Date: June 6, 2016

Project 13125.00

Re: Avalon Sudbury  
Site and Traffic Engineering Review Comments

**Figure #1**

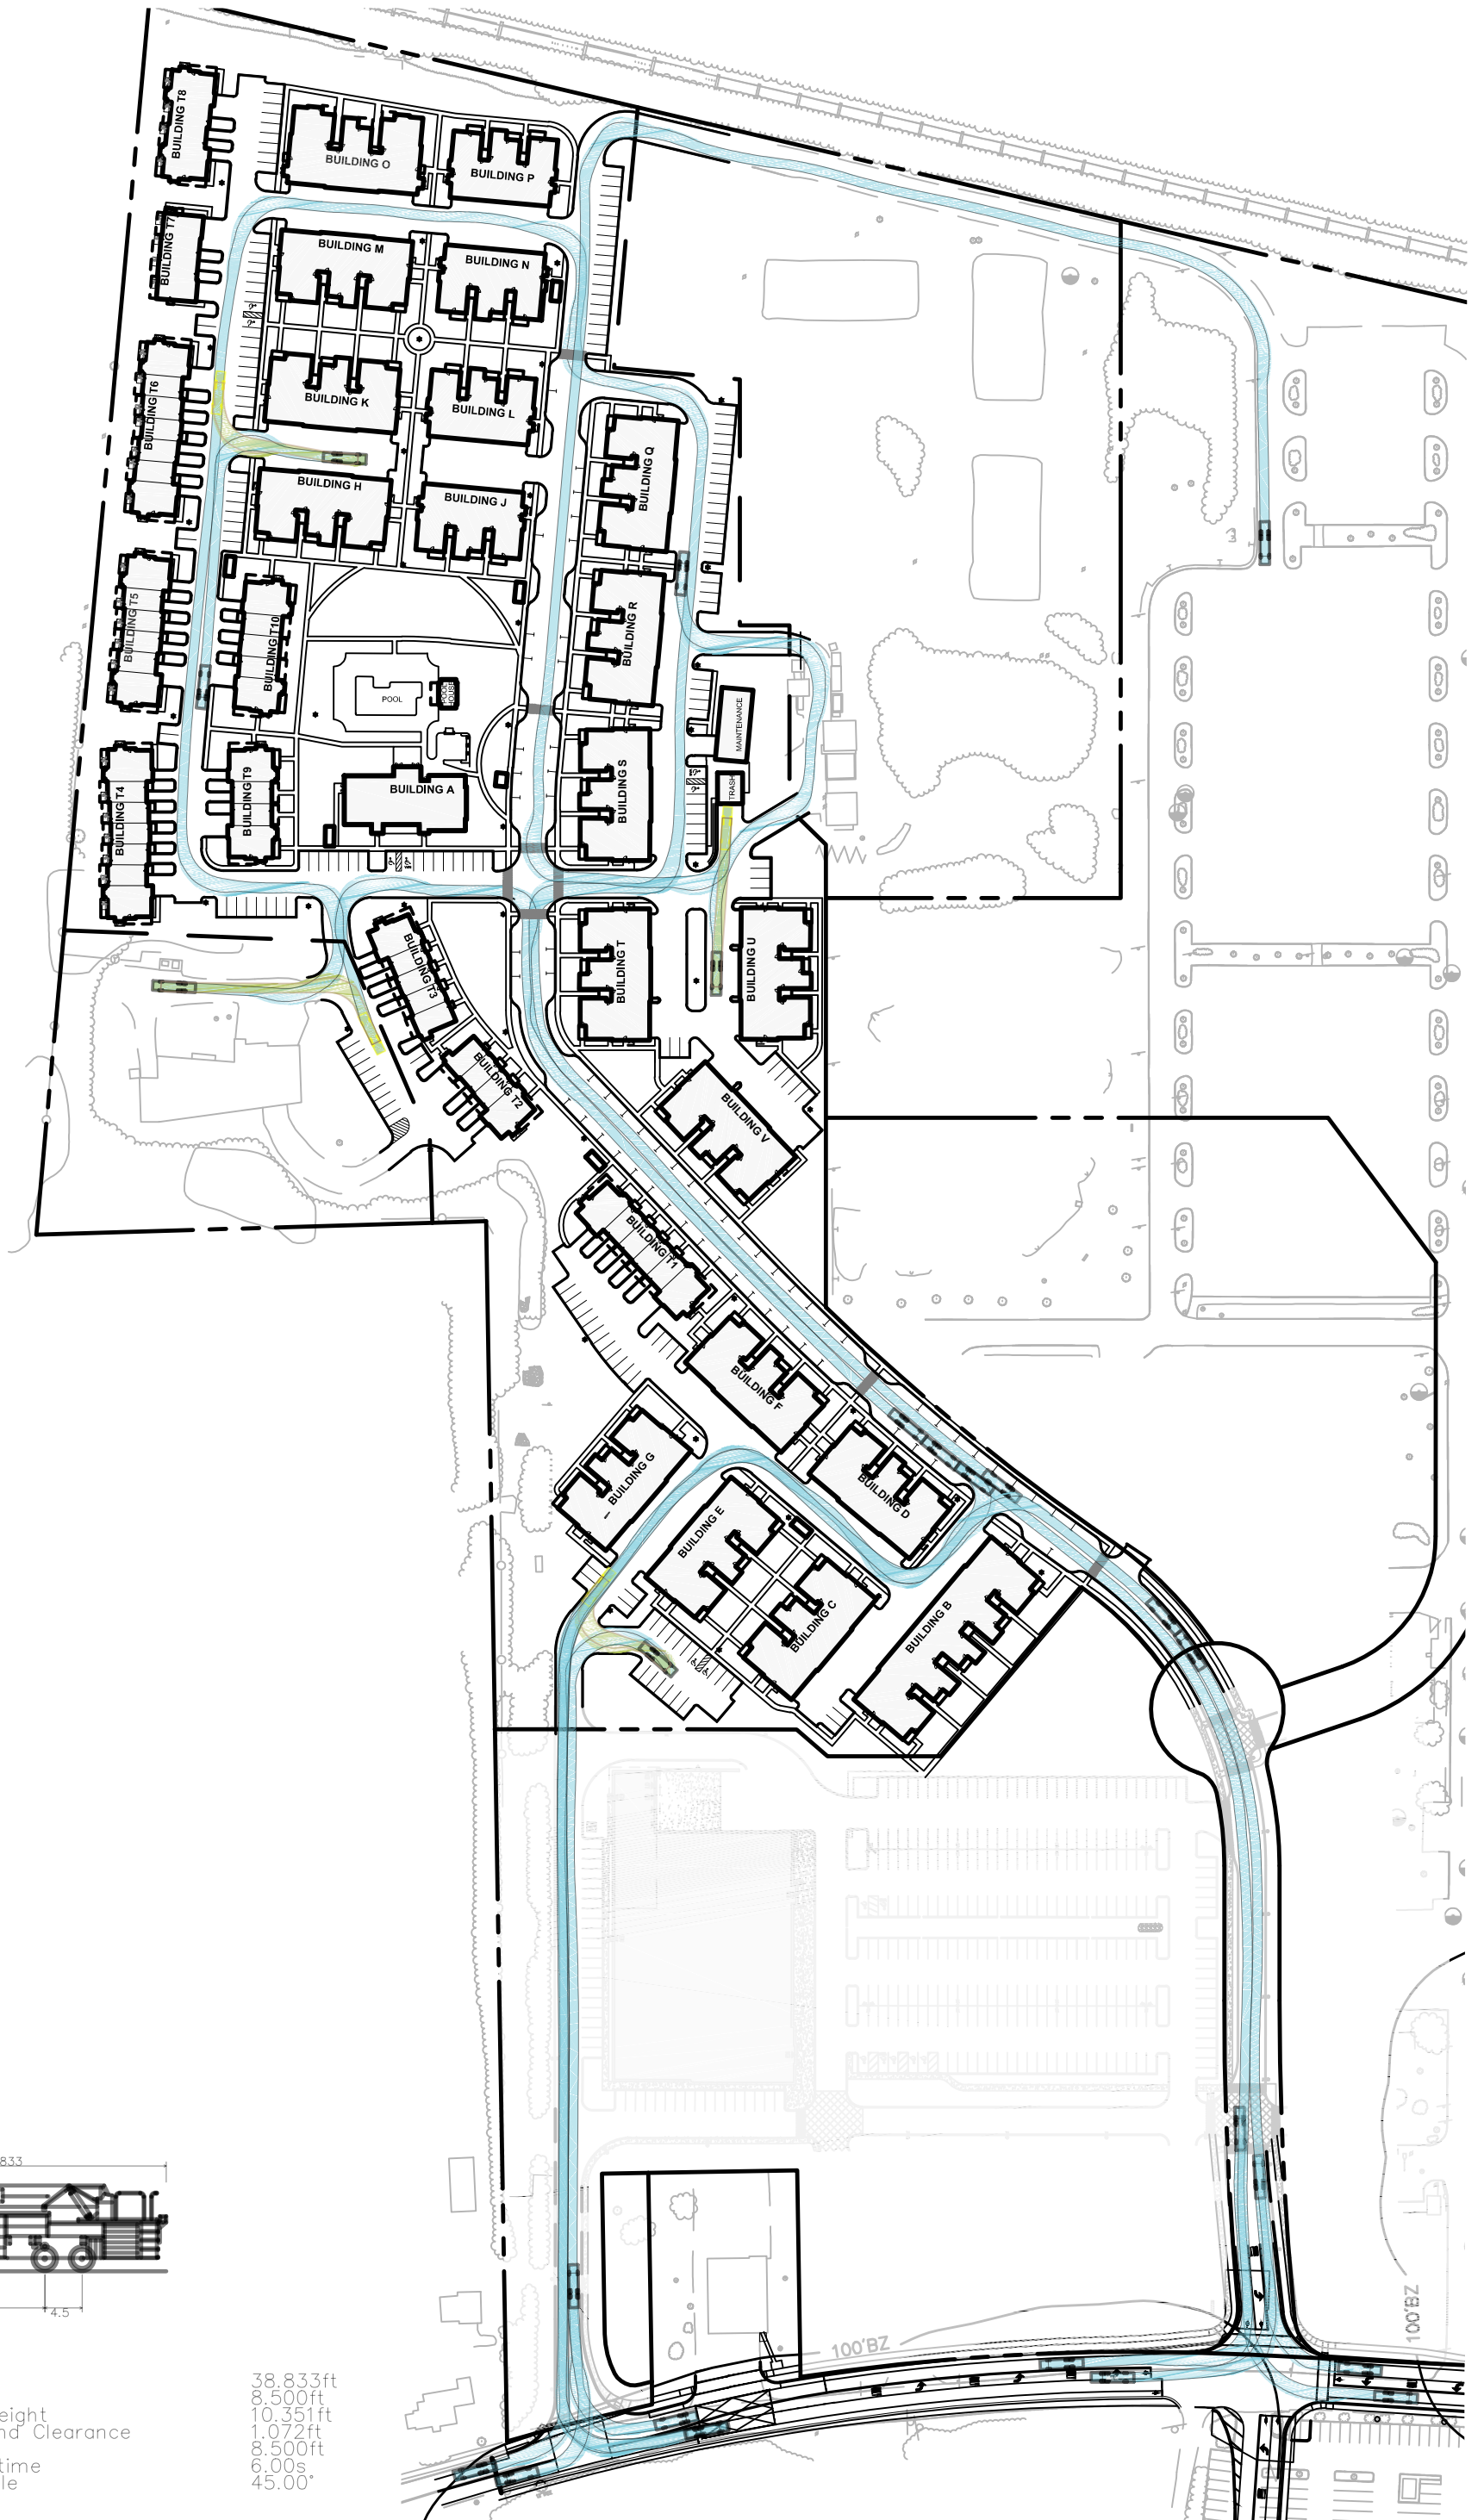
*A truck turning analysis should be completed for the Project using the following design parameters as guidance: i) the analysis should be completed using the AutoTurn® or similar analysis software for the following design vehicles: an SU-30/40 (small delivery/moving vehicle and trash/recycling vehicle) and the Town of Sudbury Fire Department design vehicle; ii) the analysis should include the swept path for the front and rear tires of the design vehicles and any overhangs that may extend past the front and rear bumper of the vehicle (i.e., basket of the aerial ladder of the fire truck if so equipped); iii) the analysis should depict all maneuvers required to enter and exit the Project site by way of Route 20 (both left and right-turn movements entering and exiting), and all turning and maneuvering required within the Project site; iv) Back-up maneuvers, where required, should be clearly identified.*

A truck turning analysis has been completed for the Project using Vehicle Tracking software and figures showing paths through the Site and both left and right-turn movements entering and exiting at Route 20 for a Sudbury Fire Truck and an SU-40 truck, representing both a moving vehicle and the Project trash truck, are attached. Vehicle overhangs are accounted for in the turning template.
